**From:** Elizabeth Hansel <ehansel@vineyardwind.com>  
**Sent:** Tuesday, June 1, 2021 10:42 AM  
**To:** Jeff Ribeiro  
**Cc:** Tricia Foster; Ted Barten  
**Subject:** RE: Vineyard Wind 1 Minor Modification Type 1 Request

**Reference: Supplemental Submittals for Vineyard Wind Substation Stormwater Report**

## UPLAND 220kV TRANSMISSION CABLE SUBSTATION CIVIL PLANS

TITLE:  
**PROPOSED GRADING & DRAINAGE (AIS)**

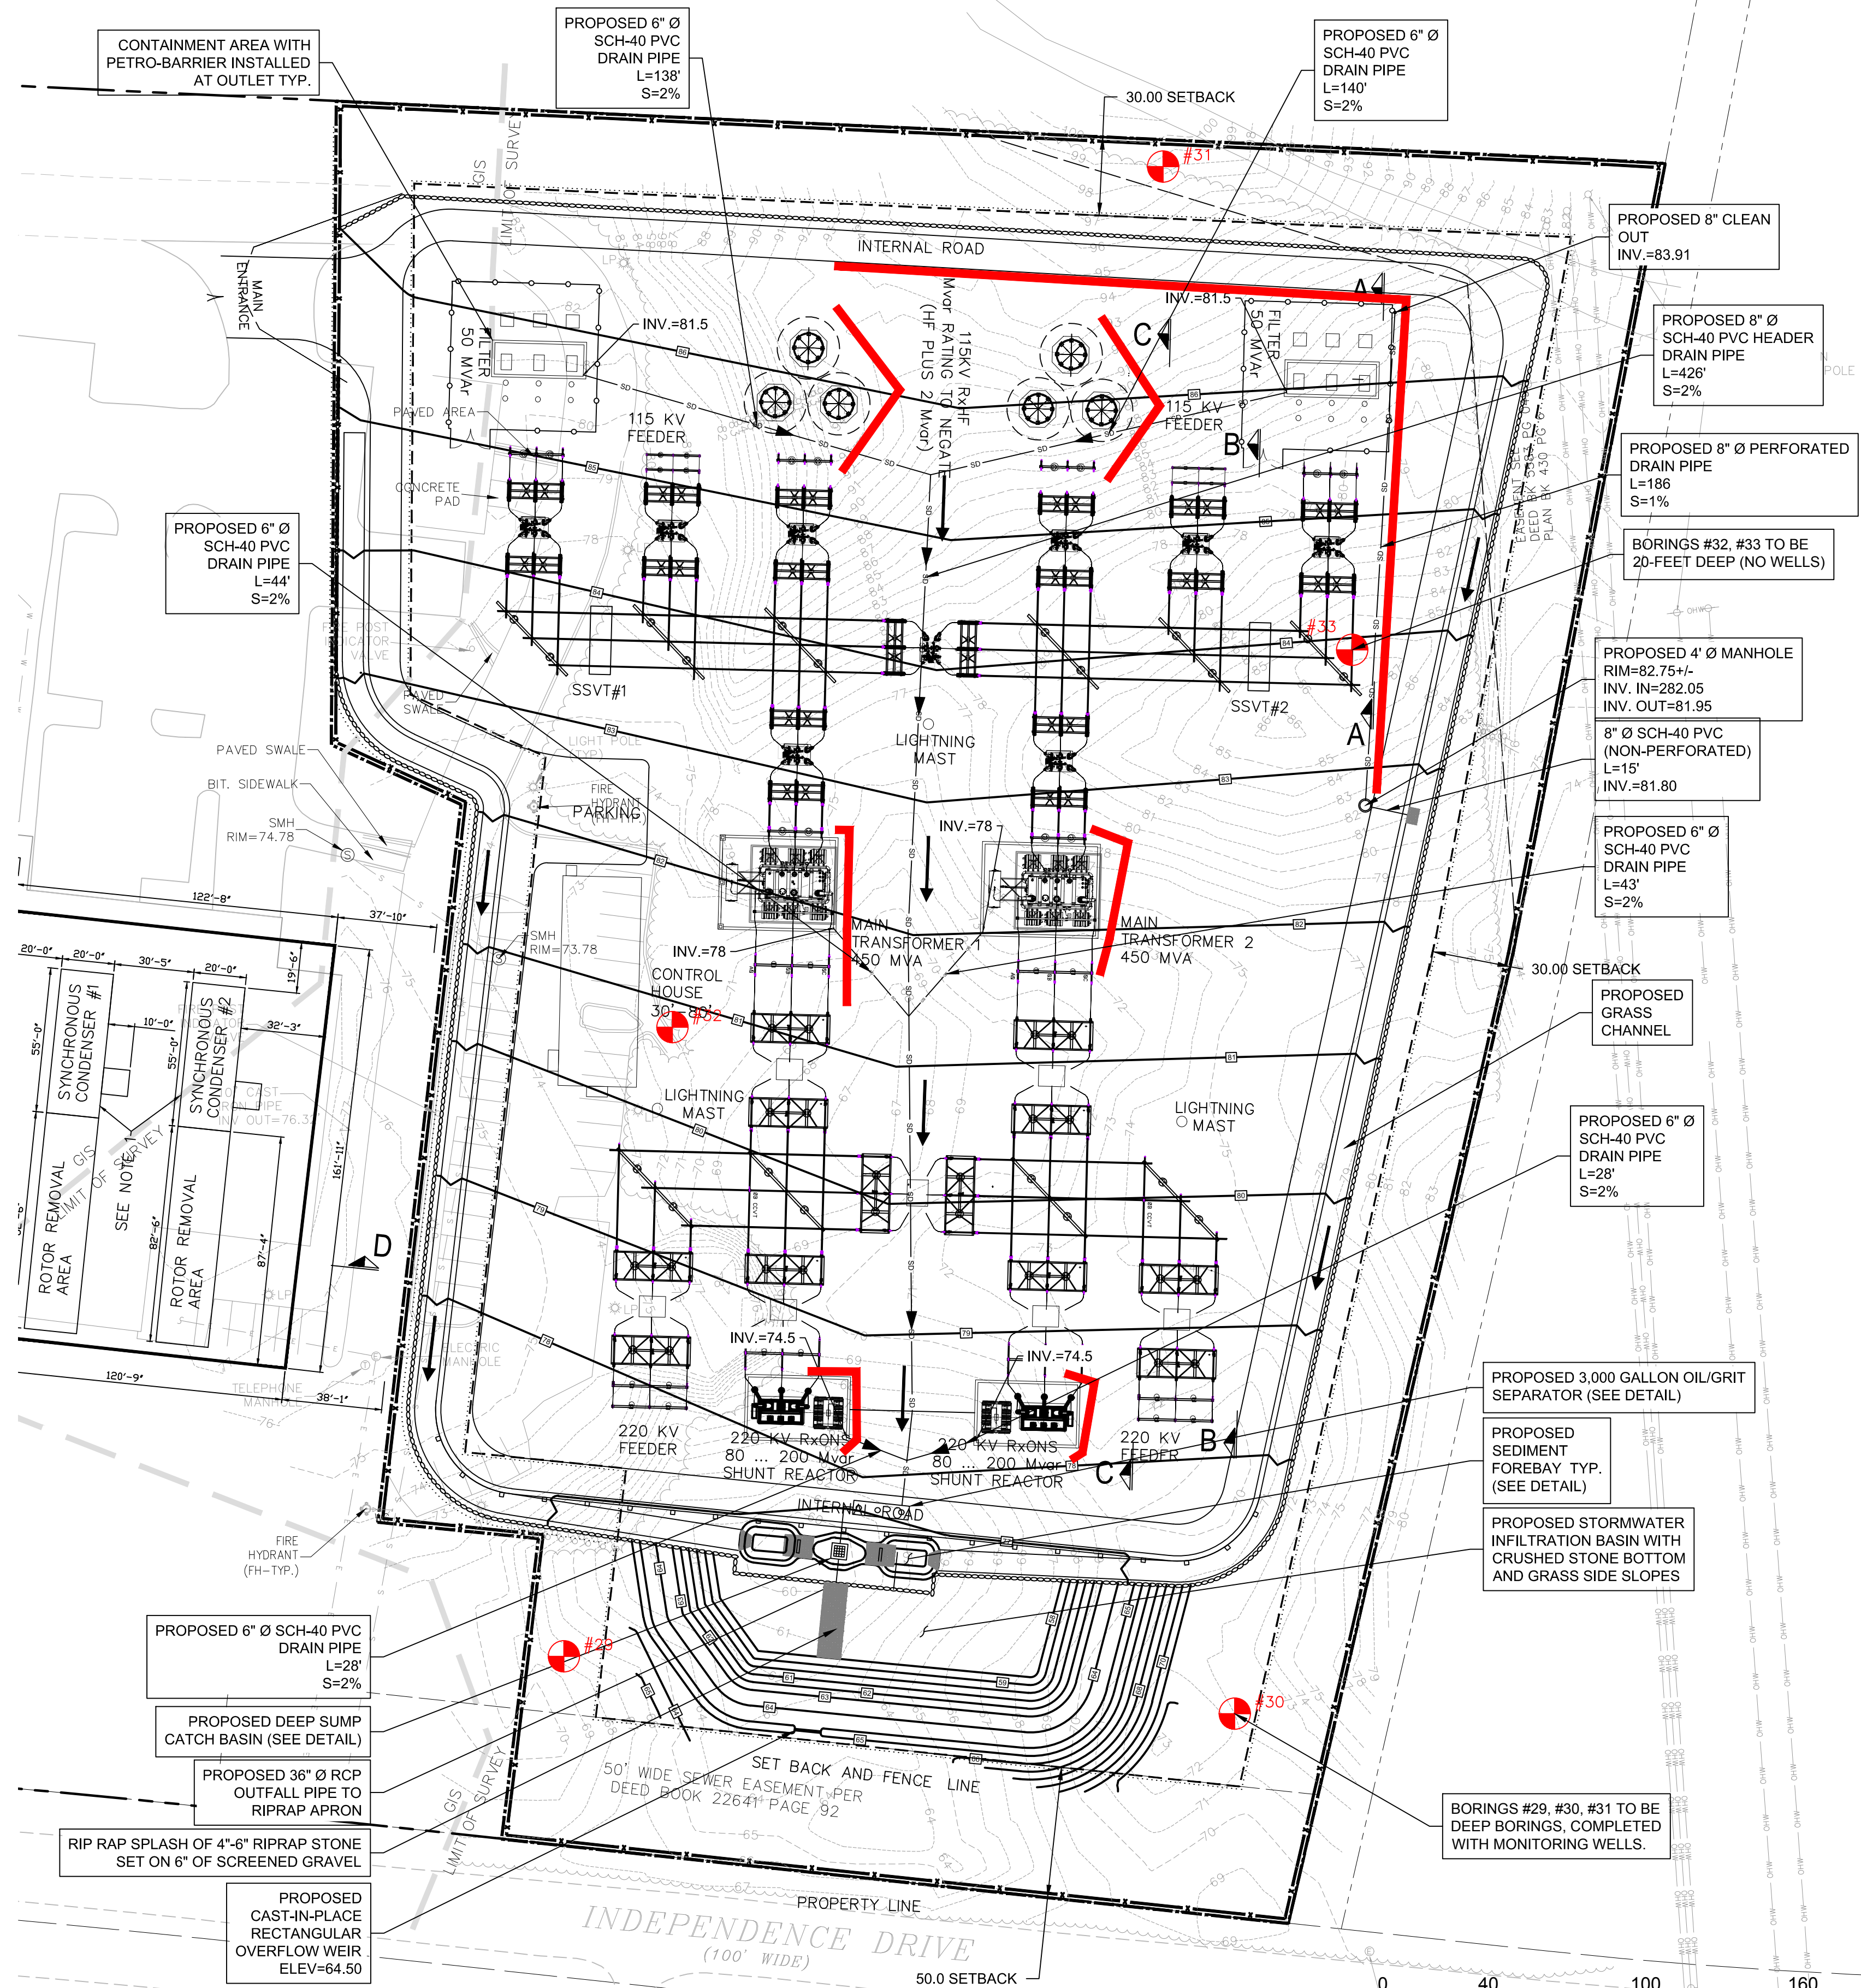
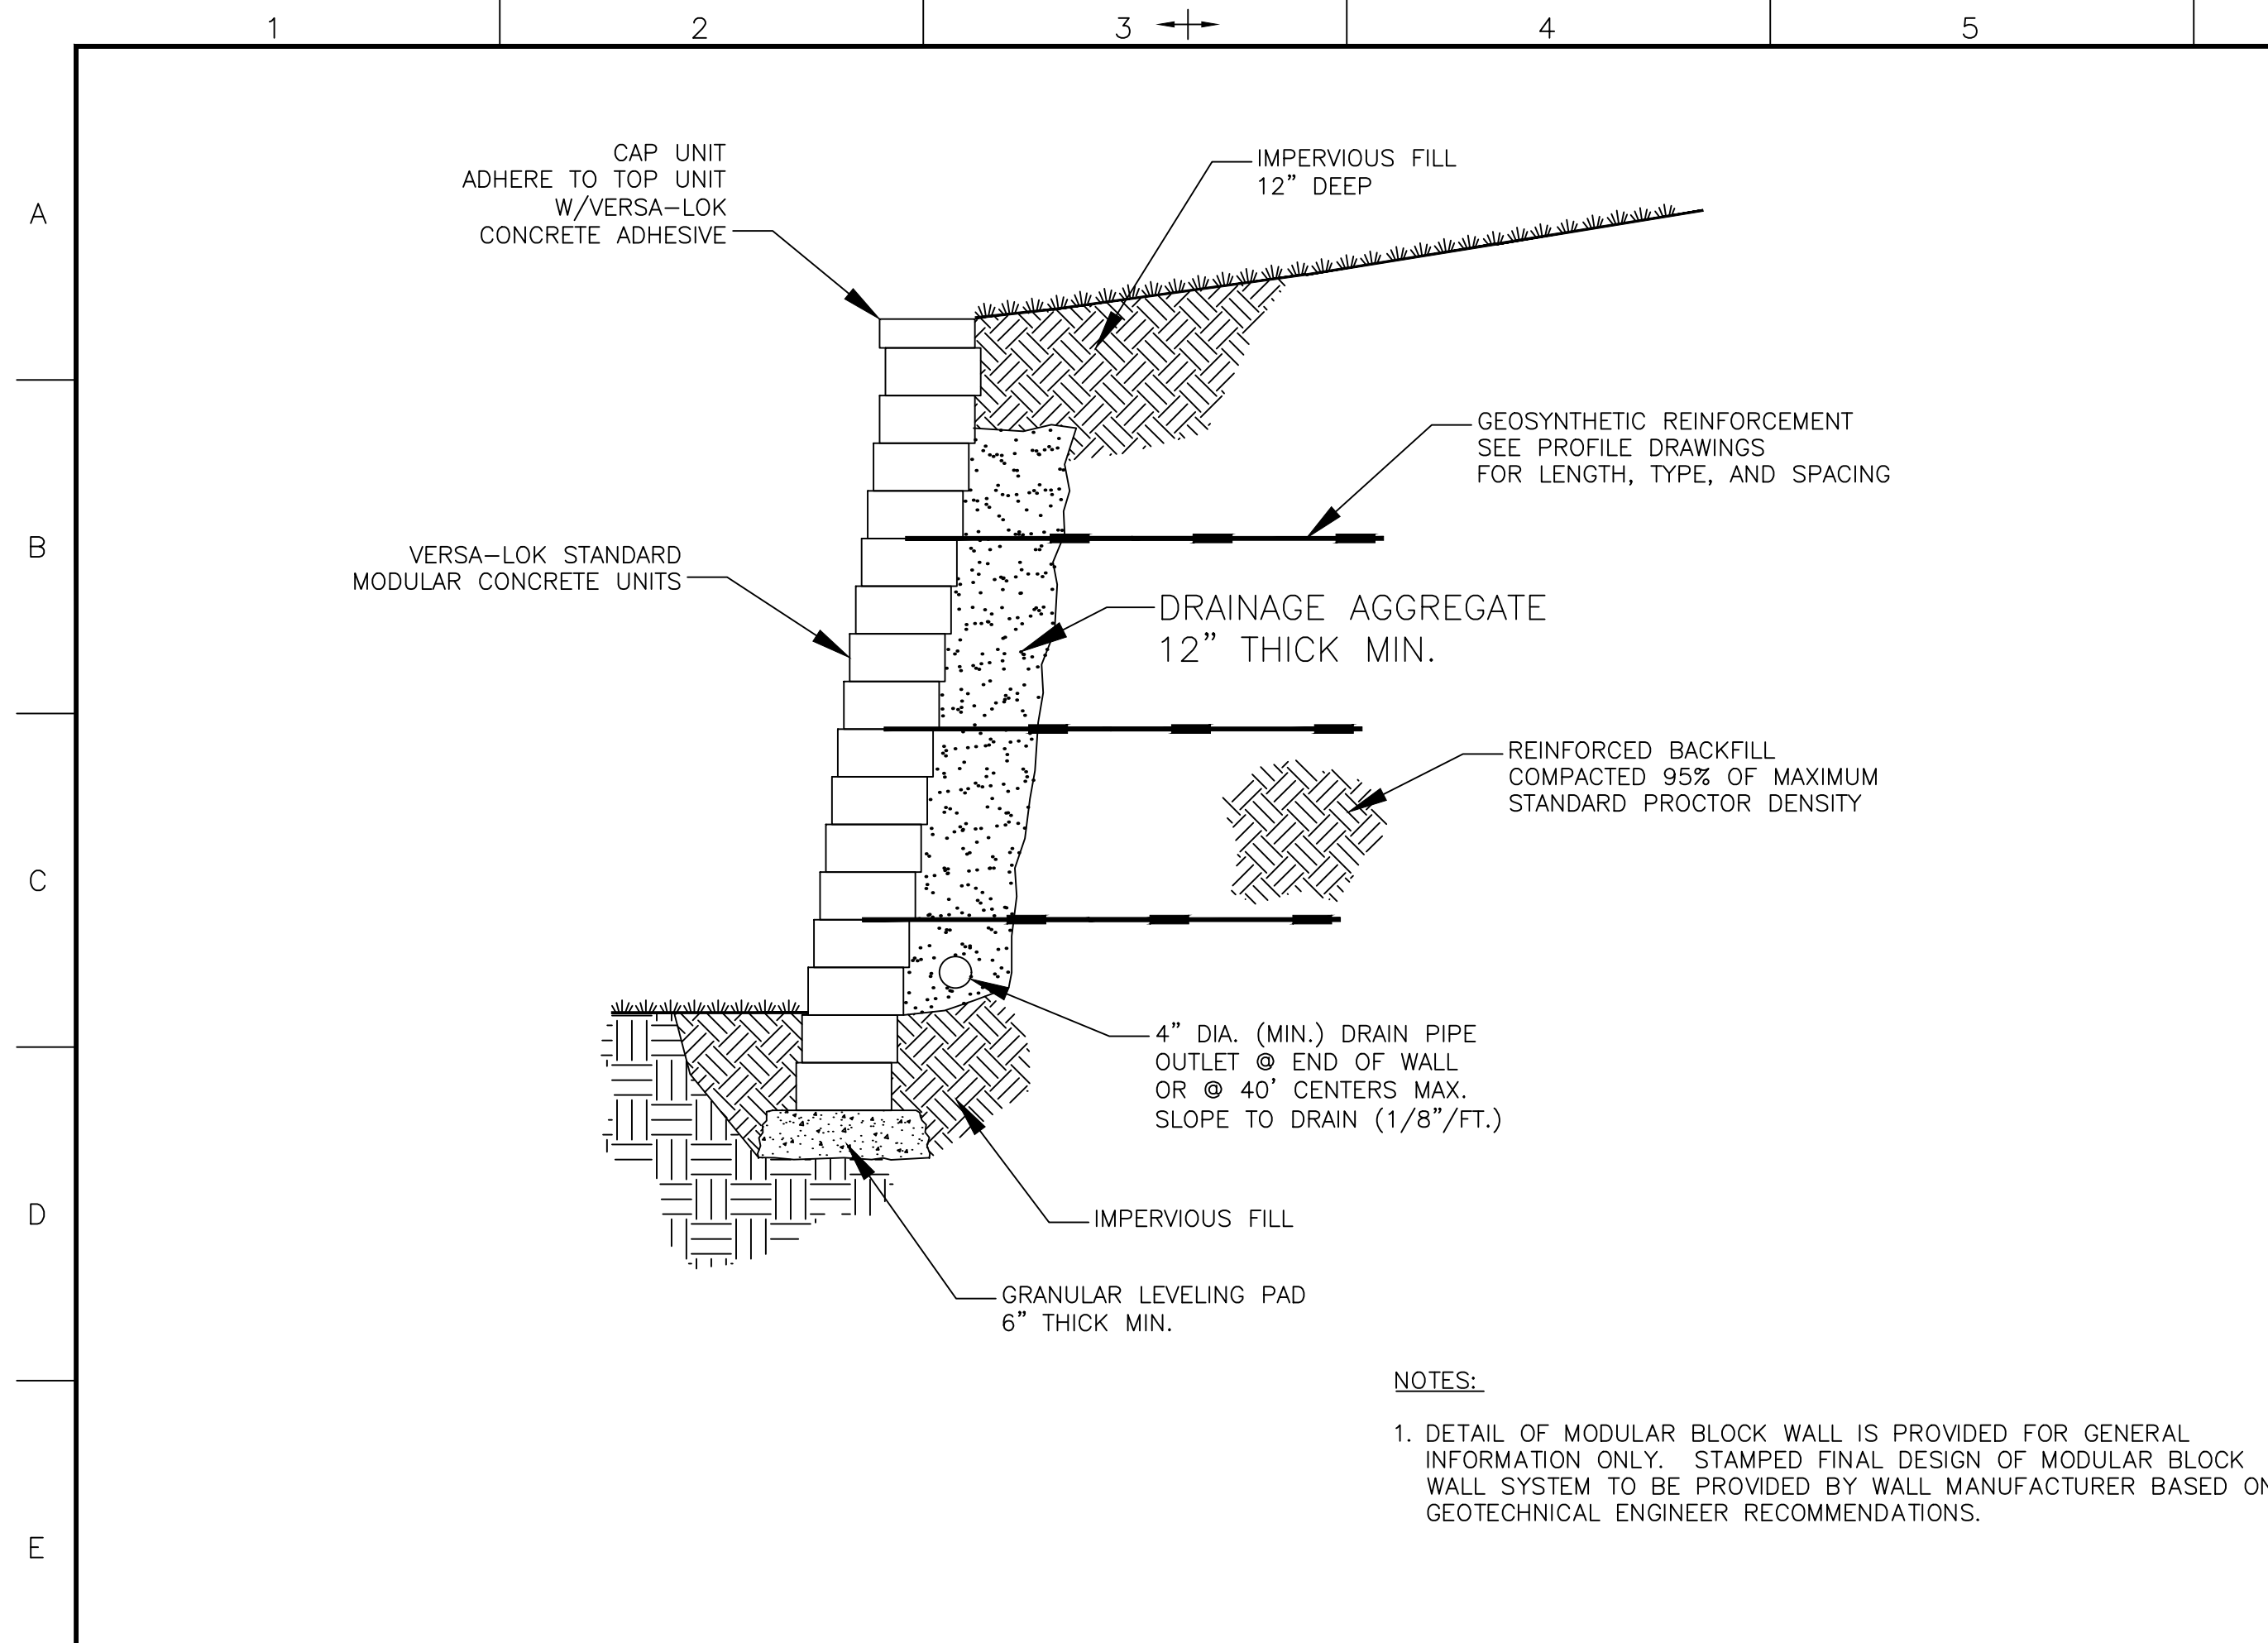
3. Revised substation drawing detail sheets see attached revised substation plans, revised to include cross sections for certain treatment train features (e.g. swales, forebays, deep sumps, Petro-Barriers).
